**Water Resources  
Report on the Santa Clara River**

**Prepared by United Water Conservation District  
Castaic Lake Water Agency**

**April 1996**

Water Balance for Los Angeles County  
 May 1995  
 K/J 934625.00  
 Source: Kennedy/Jenks Consultants  
 Figure 22

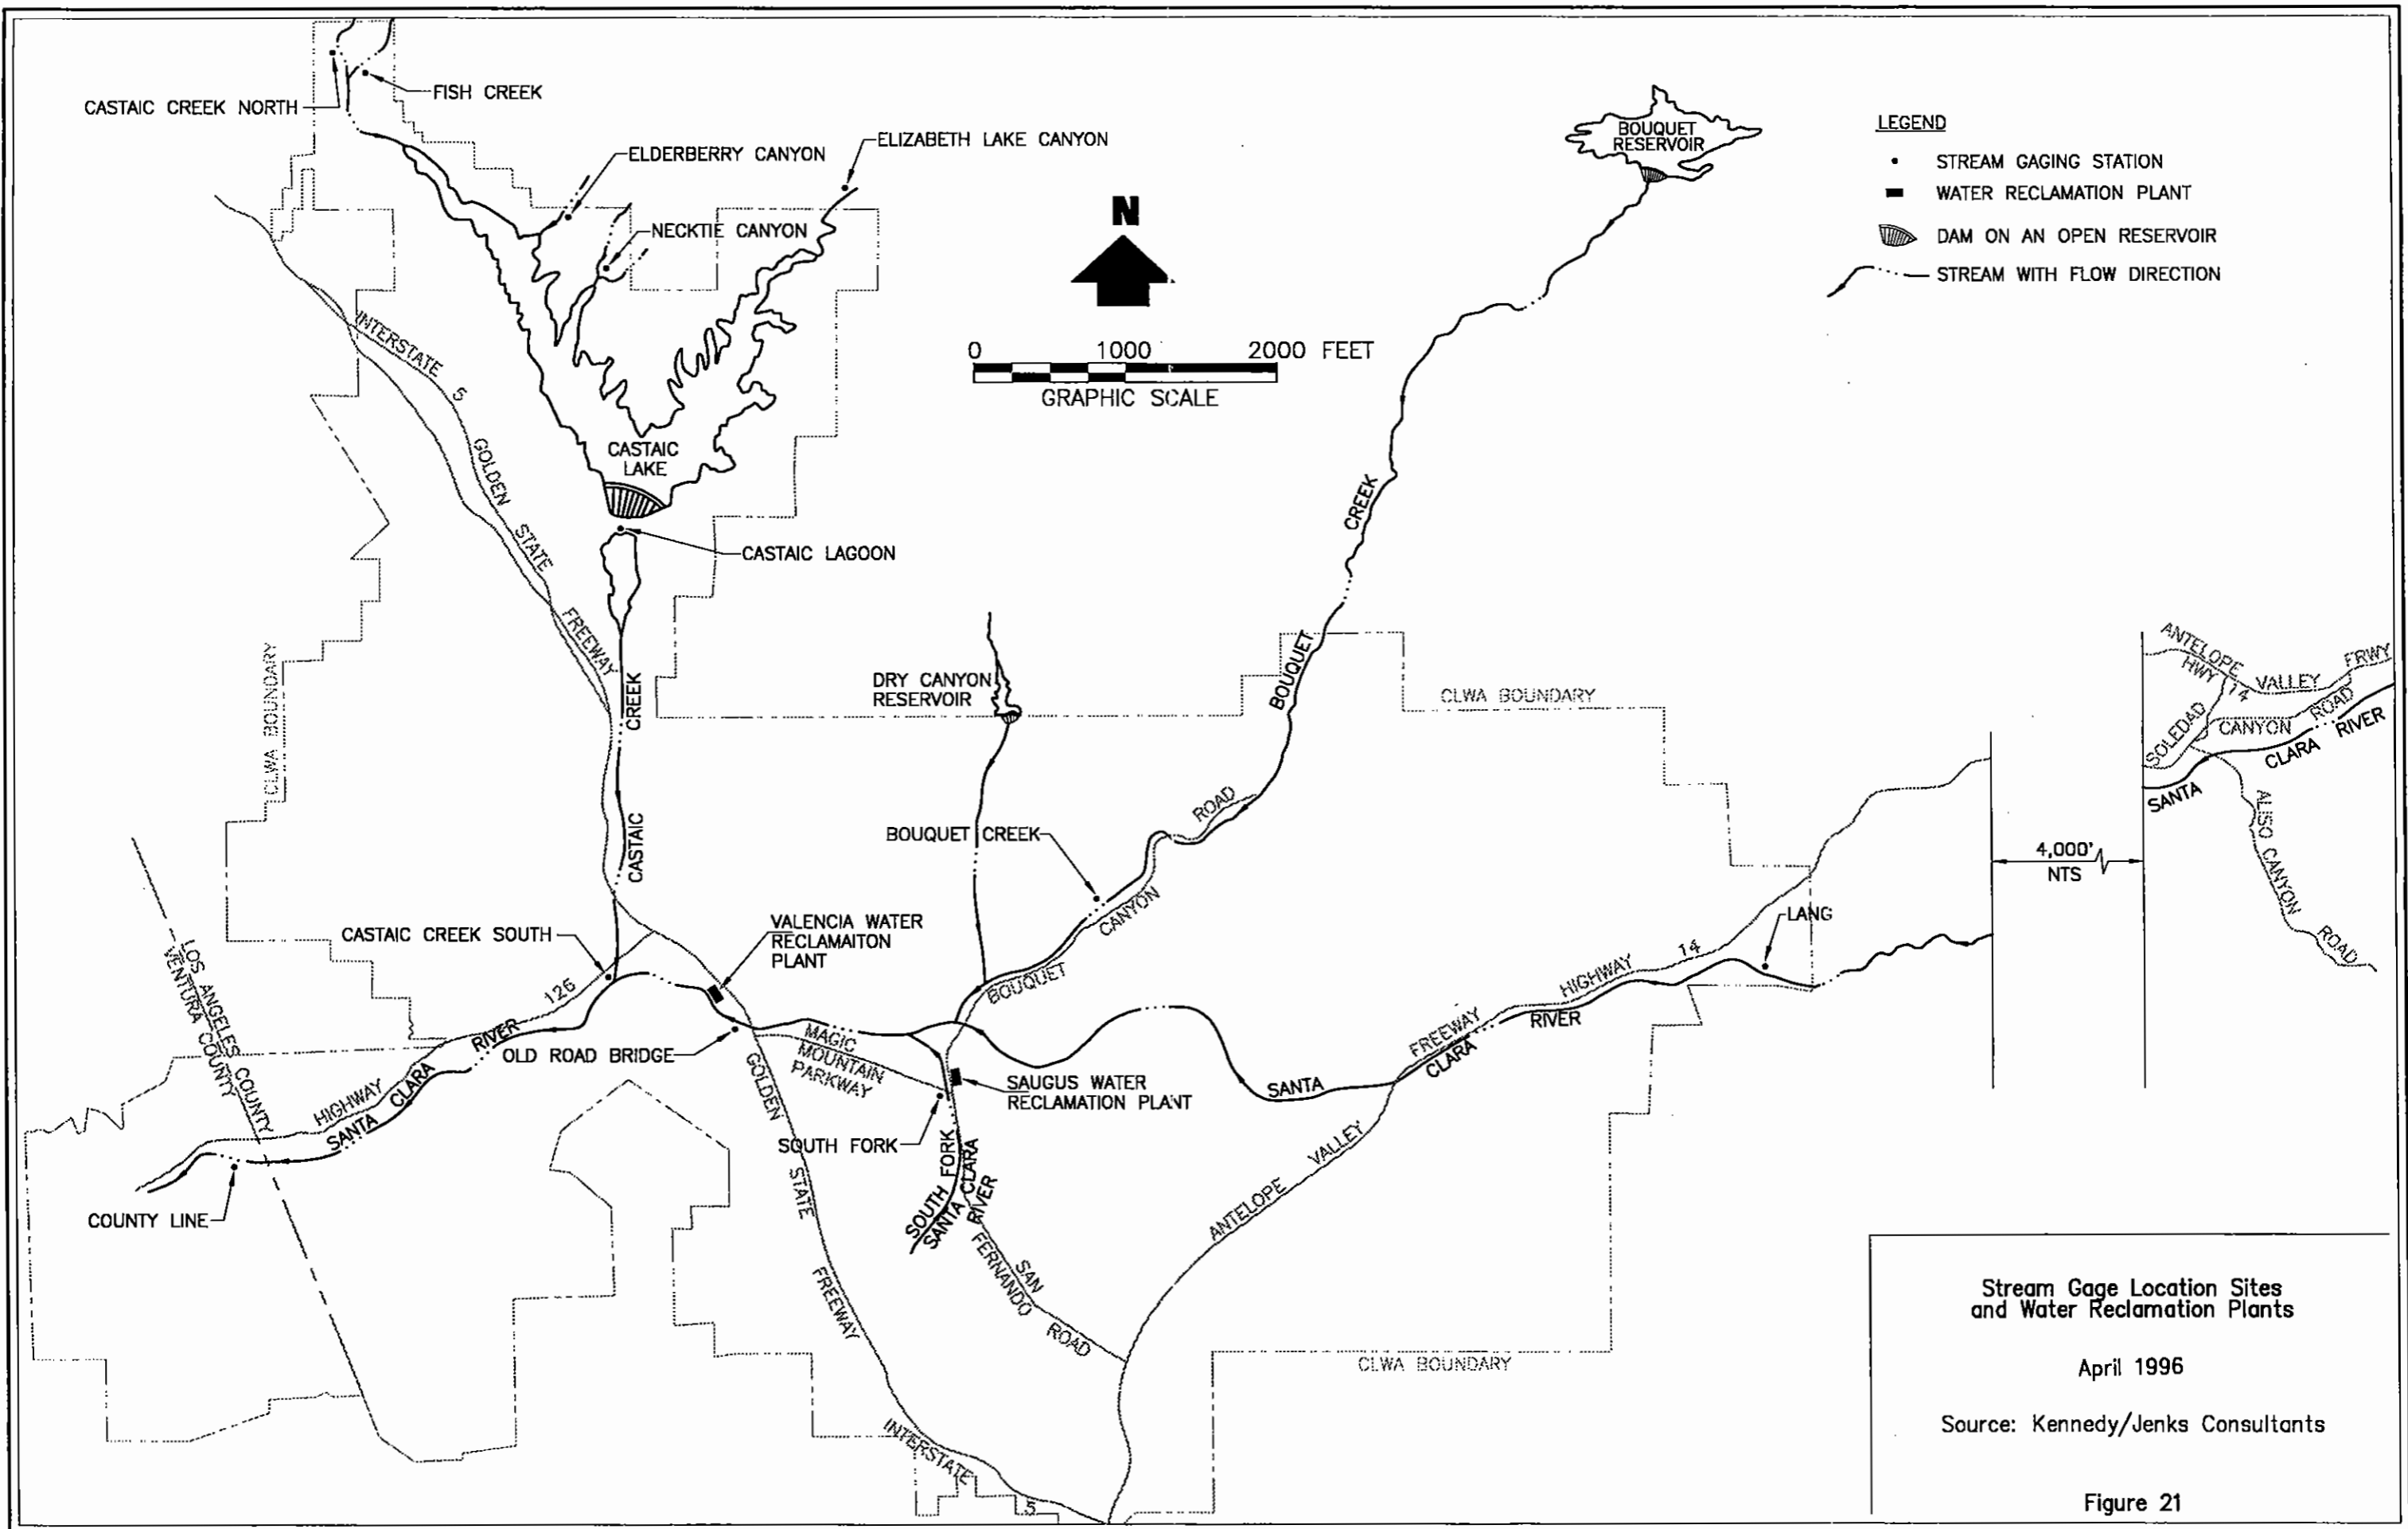
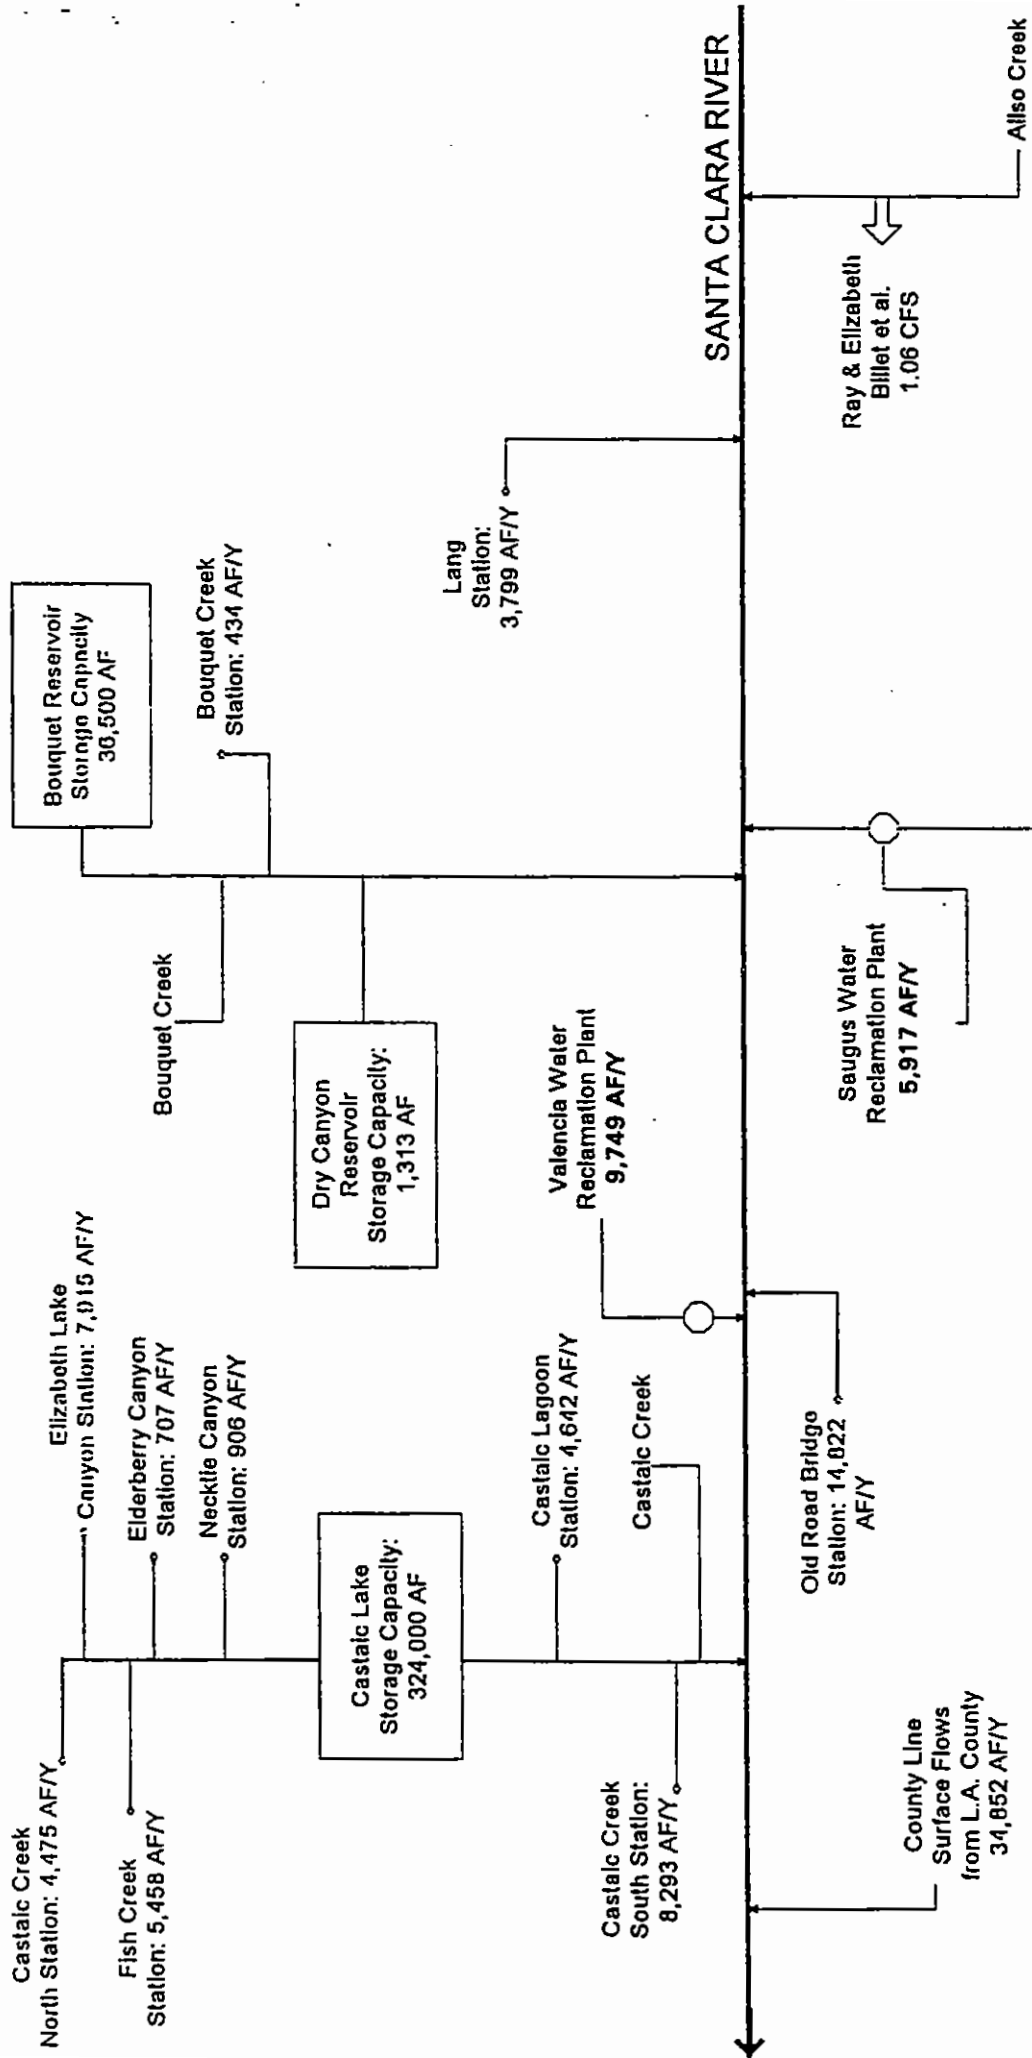
(1) Figure 22 - It is unclear what the current and future flows (AF/Y) shown for Valencia and Saugus WRPs represent. It appears that the values should represent the effluent flows being discharged from the respective treatment facilities into the Santa Clara River. If that is the case, the values shown are incorrect. Otherwise, please clarify what the flows are representing.

- D7 Figure 22: *Water Balance for Los Angeles County*. The indicated acre feet of water generated from the two noted reclamation plants is incorrect and grossly understated. Please refer to charts listed in the *Water Reclamation* section. Quantities there are quoted in MGD, but can be converted to AF.

- B1. The annual averages for the total plant effluent contained in Figure 22 have been revised. The annual average effluent for 1992 for Valencia and Saugus Water Reclamation Plants was 9,749 and 5,971 AF/Y, respectively.

- D7. Figure 22 Water Balance, the annual averages for the total plant effluent contained in Figure 22 have been revised. The annual average effluent for 1992 for Valencia and Saugus Water Reclamation Plants was 9,749 and 5,971 AF/Y, respectively.
